**ELECTRONIC APPLICATION OF)
BIG RIVERS ELECTRIC CORPORATION)
FOR A CERTIFICATE OF PUBLIC)
CONVENIENCE AND NECESSITY TO)
CONSTRUCT A 161 KV TRANSMISSION LINE)
IN HENDERSON COUNTY, KENTUCKY)**

**Case No.
2022-00012**

**Responses to Commission Staff's
Second Request for Information
dated April 1, 2022**

**TRANSMISSION SYSTEM
HENDERSON AREA**

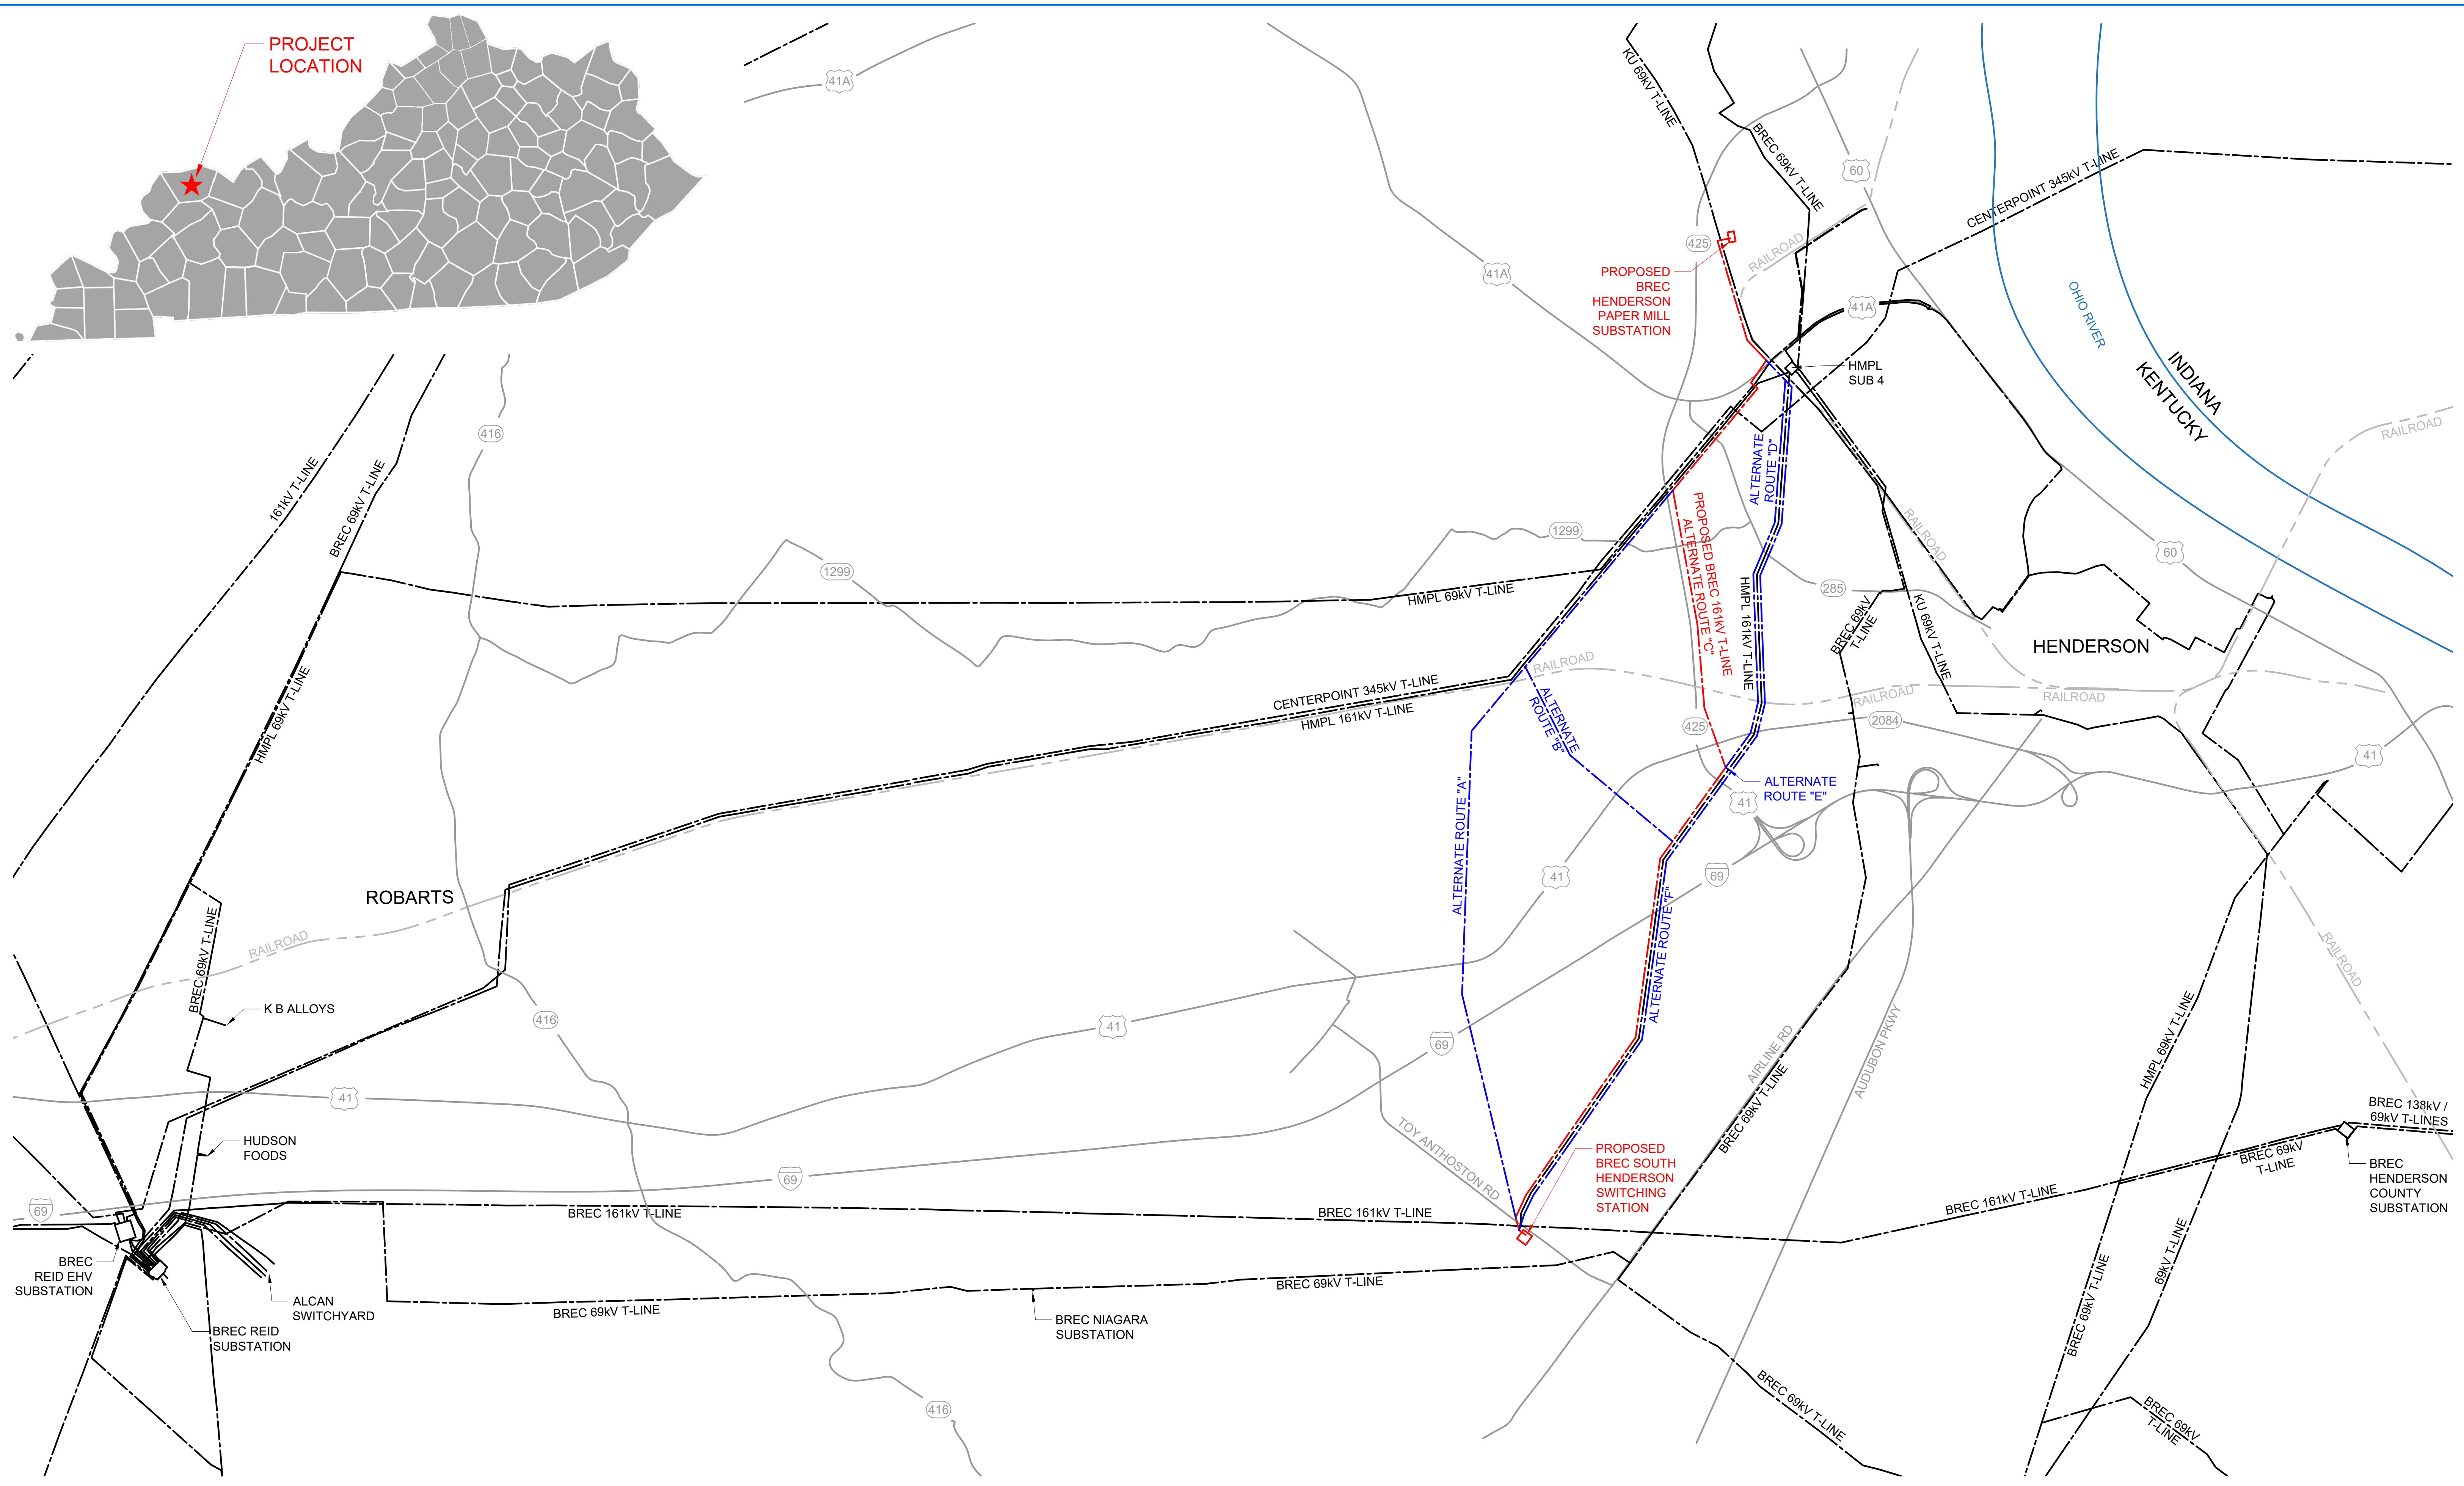
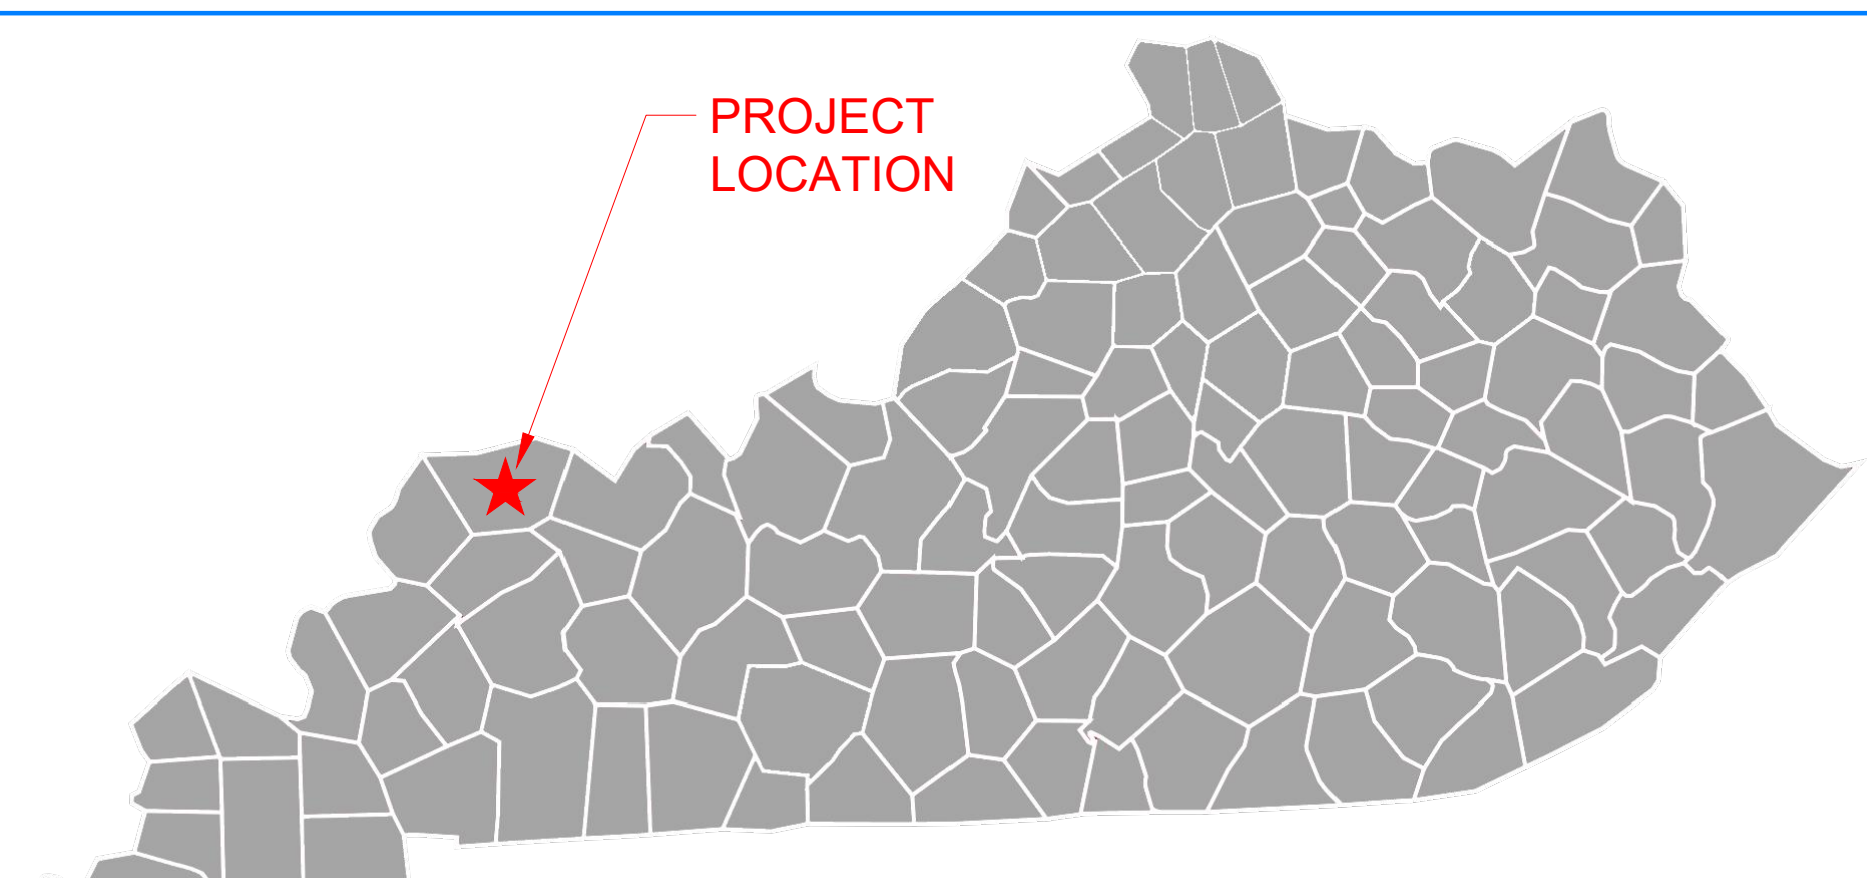
7 *c. Also refer to BREC's response to Commission Staff's First request,*
8 *Item 12. It appears that the proposed 161 kV line will tie in with the existing*
9 *161 kV T Line at the new proposed substation, perhaps looping two circuits.*
10 *Provide a map which shows the broader transmission configuration and*
11 *explain further how tying the two lines together enhances reliability and*
12 *accommodates expected load growth.*

- 10 c. Please see the attached Exhibit PSC 2-2(c), which expands on the
11 previously provided vicinity map to show the Big Rivers transmission
12 system between the Reid Substation and the Henderson County
13 Substation. The exhibit depicts the existing 161 kV transmission line
14 described in the response to subpart b of this response. This existing
15 transmission line connects the Big Rivers owned Reid Substation to the
16 Big Rivers owned Henderson County Substation. A HMPL owned 161 kV

1 circuit connects the existing HMPL Sub 4 to a midpoint on this same Big
2 Rivers owned transmission line with three line switches. This connection
3 of the Big Rivers and HMPL owned transmission lines create a three
4 terminal facility with circuit breakers located at each of the three
5 terminals (Reid Substation, Henderson County Substation and HMPL
6 Sub 4). A fault on any portion of these lines will result in an outage of the
7 entire Big Rivers 161 kV transmission line and the HMPL 161 kV line.
8 The replacement of the line switches with a switching station that
9 includes 161 kV circuit breakers creates a more robust, flexible, and
10 reliable configuration allowing for restoration of the 161 kV line after a
11 fault more quickly than the existing design. With the proposed switching
12 station configuration and the proposed transmission line, four individual
13 161 kV line sections with circuit breakers at each terminal of each line

- 1 1. Reid Substation (BREC) to the proposed South Henderson Switching
2 Station (BREC) – *portion of existing Big Rivers owned transmission*
3 *line*
- 4 2. Henderson Co. Substation (BREC) to South Henderson Switching
5 Station (BREC) – *portion of existing Big Rivers owned transmission*
6 *line*
- 7 3. South Henderson Switching Station (BREC) to HMPL Sub 4 (HMPL) –
8 *existing HMPL owned transmission line*
- 9 4. South Henderson Switching Station (BREC) to Henderson Paper Mill
10 Substation (BREC) – *the proposed transmission line.*

11 Any of the four individual line sections can be outaged on a planned or
12 unplanned basis without impacting the other line sections. Additionally,
13 the proposed South Henderson Switching Station will be constructed to
14 allow the future addition of 161/69 kV transformer(s) to provide service to
15 Kenergy distribution substations in the vicinity as needed.
